**AGENDA**  
**Cascade Charter Township Zoning Board of Appeals**  
**Tuesday, August 9, 2016**  
**7:00 pm**  
**Cascade Library Wisner Center**  
**2870 Jacksmith Ave. SE**

STAFF REPORT: Case #16-3319  
REPORT DATE: August 3, 2016  
PREPARED FOR: Cascade Charter Township Zoning Board of Appeals  
MEETING DATE: August 9, 2016  
PREPARED BY: Steve Peterson, Community Development Director

REQUESTED ACTION: The applicant is requesting approval from the Zoning Board of Appeals to construct a new service bay that does not comply with front setbacks, style of roof and use of chain link fence.

**ROOF PLAN**

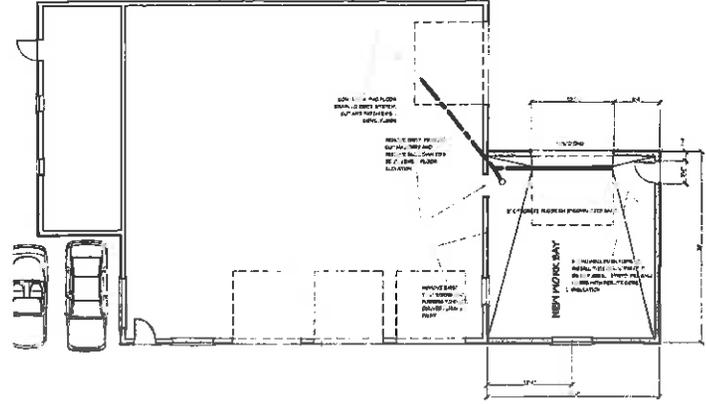
issue	Request	Zoning requirement
Front setback	16 feet	20 feet min. 30 feet max
Roof style	Mansard	Normally considered inappropriate
Chain link	Keep chain-link	prohibited

6. The building is setback from the Cascade Rd ROW at 16 feet. They would simply like to maintain the existing setbacks. The intent of the setbacks was to bring building closer to the road and eliminate front yard parking. By maintaining the existing setback they would achieve the intent of the village but it requires a variance
7. The style of roof was left a little vague in the ordinance. The ordinance states, "roof styles Normally considered inappropriate include shed and mansard". While the applicant agrees that this is a mansard style roof they are simply matching what is there now.
8. Chain link fence is strictly prohibited. The applicant would like to continue the use of the chain link fence. In order to come into compliance they would either have to remove the fencing or choose another material, such as wood, vinyl, wrought iron, etc

Approve the variance for the front setback  
Approve the variance for the mansard style roof  
Deny the variance for the chain link fence.
